SERVICE BULLETIN

Classification: EC13-003b	Reference: NTB13-021b	Date: March 9, 2017
------------------------------	--------------------------	------------------------

2010-2015 FRONTIER, 2010-2012 PATHFINDER AND XTERRA; VIBRATION WHILE IDLING

This bulletin has been amended to add 2013-2015 Frontier and additional steps for that model range. Please discard the previous version of this bulletin.

Figure A

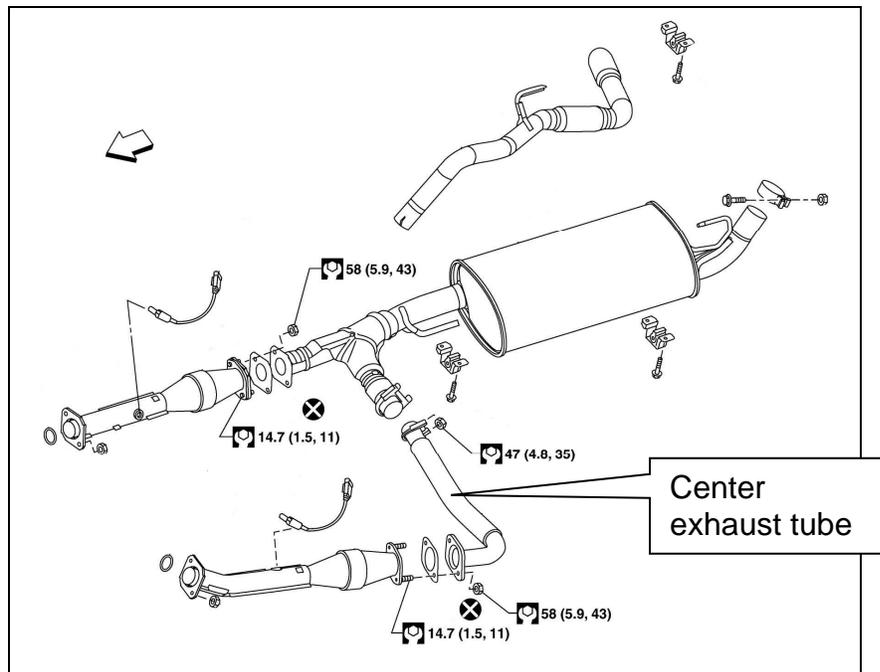
Replace the exhaust center tube (see Figure A).

- The **new** exhaust center tube (Figure B) is listed in the Parts Information.
- Refer to the Electronic Service Manual (ESM), section **EX – Exhaust System** for removal and installation information.
